INNER WEST COUNCIL

DEVELOPMENT ASSESSMENT REPORT

| Application No. | 10.2019.84 |
| Address | 79 Smith Street, Summer Hill |

Figure 6: Private open space of Unit 1 Building A. Green line denotes open space, red line denotes 'principal private open space' in accordance with the definition in the DCP.

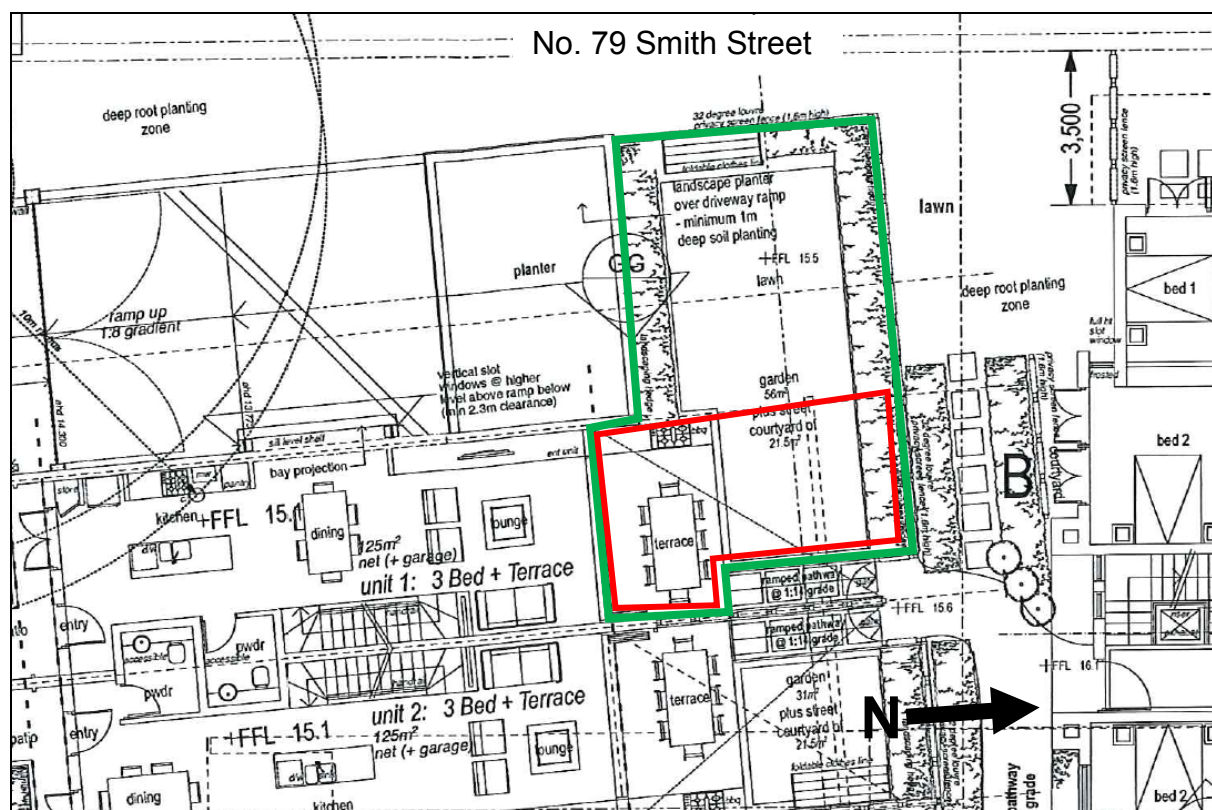
Therefore, the principal private open space of Unit 1 of Building A is taken to be the paved terrace/courtyard area directly adjoining the living area (see Figure 6 below).

The solar access diagrams show that the private open space will only receive a marginal (~2.8sqm) loss of solar access at 3pm during the winter solstice. The diagrams also demonstrate that during the equinox this area will not be impacted at all by the proposal in relation to solar access.

Figure 7: Private open space of Unit 5 Building B. Red line denotes private open space.

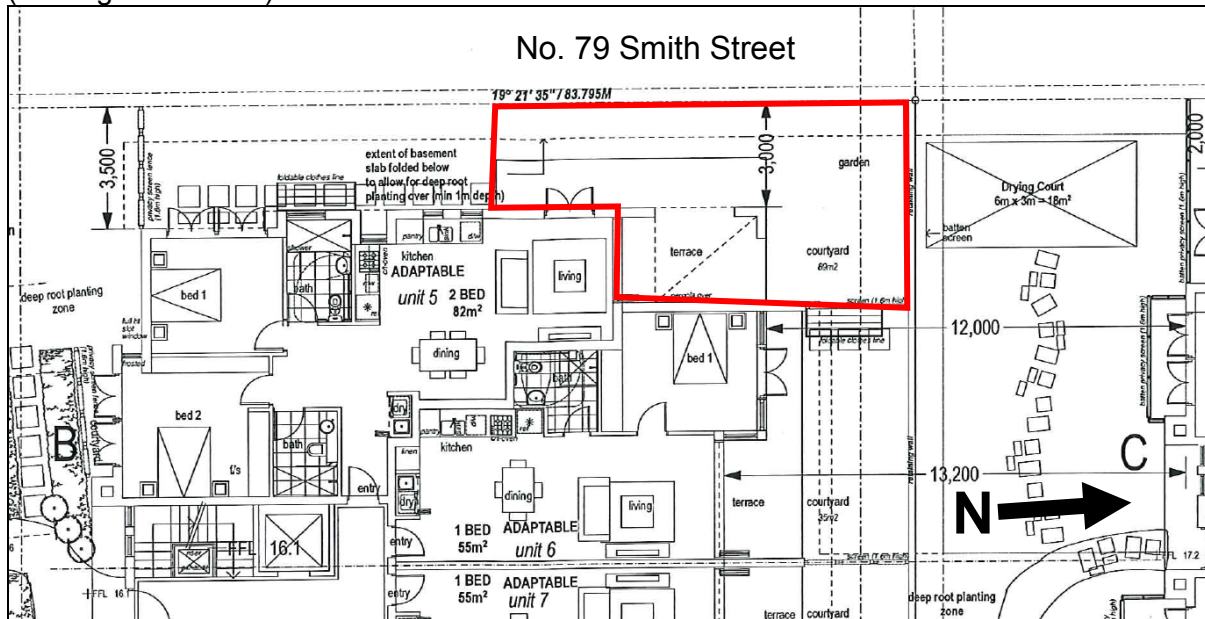
Therefore, the private open space of Unit 5 Building A is taken to be courtyard/terrace area (see Figure 7 below).

The supplied shadow diagrams demonstrate that there will be some loss of solar access to this area between 12.00 midday – 3.00pm during the winter solstice. Given the private open space is located within the side setback it is considered unreasonable to expect to maintain the current level of solar access received from the underdeveloped nature of the subject site.

Figure 8: Private open space of Unit 9 Building B. Red line denotes private open space.

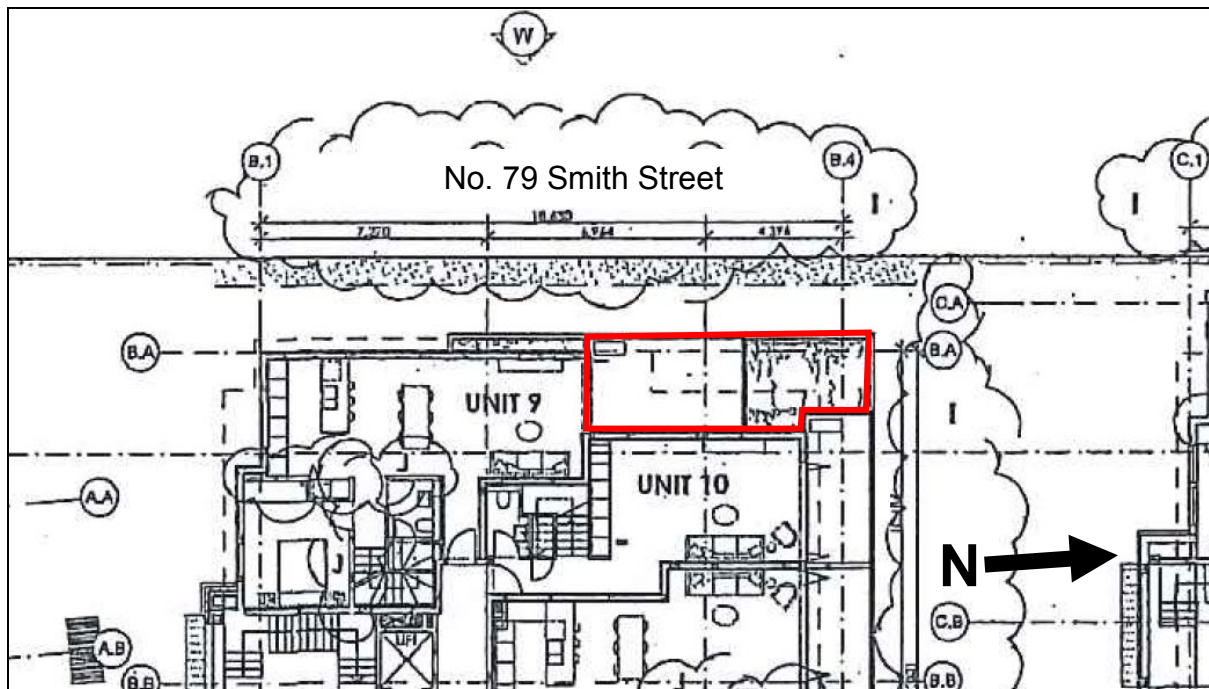
The private open space of Unit 9 of Building B (as labelled on the Construction Certificate plans) is taken to the first floor deck (see Figure 8 below).

Although there will be some loss of solar access to this area between 1.00pm – 3.00pm during the winter solstice, the supplied shadow diagrams demonstrate that this private open space will receive ample sunlight between 9am – 12.00 midday during the winter solstice in accordance with the DCP.
